McLaren Senna GTR – Rear Wing Rework

Bulletin type:	Service Campaign
Reference number:	SCB 15 A 002
Attention:	Retailer Service Managers and Retailer Technicians
Affected vehicles:	McLaren Senna GTR
Situation:	Adhesion of the rear wing in the upper end plate area may be insufficient
Procedure:	Action affected vehicles during next Retailer visit. Please refer to the information outlined in this document to rework the rear wing
Date:	12 th March 2020

Extract from SCB 15 A 002 WI – Application area of adhesive (6)

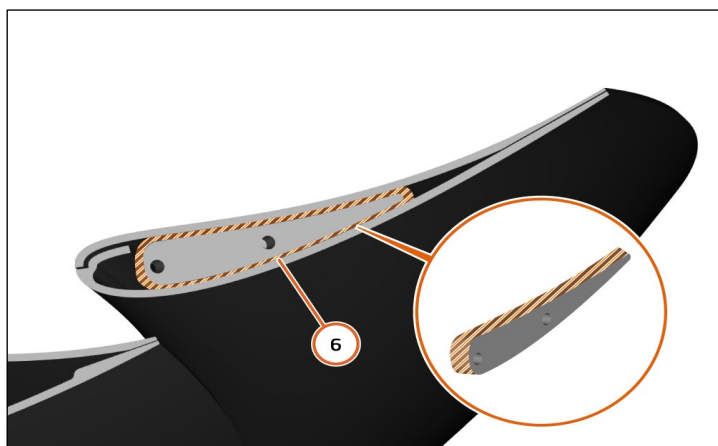
Through continuous product quality monitoring, it has been identified that a number of McLaren Senna GTR vehicles may have insufficient adhesion on the rear wing in the upper end plate area.

To carry out the required rework, the re-application of adhesive is required.

Document SCB 15 A 002 WI (attached with this Bulletin) contains the relevant work instructions and care points to ensure the repair is carried out correctly, bringing the vehicle up to the current manufacturing standard.
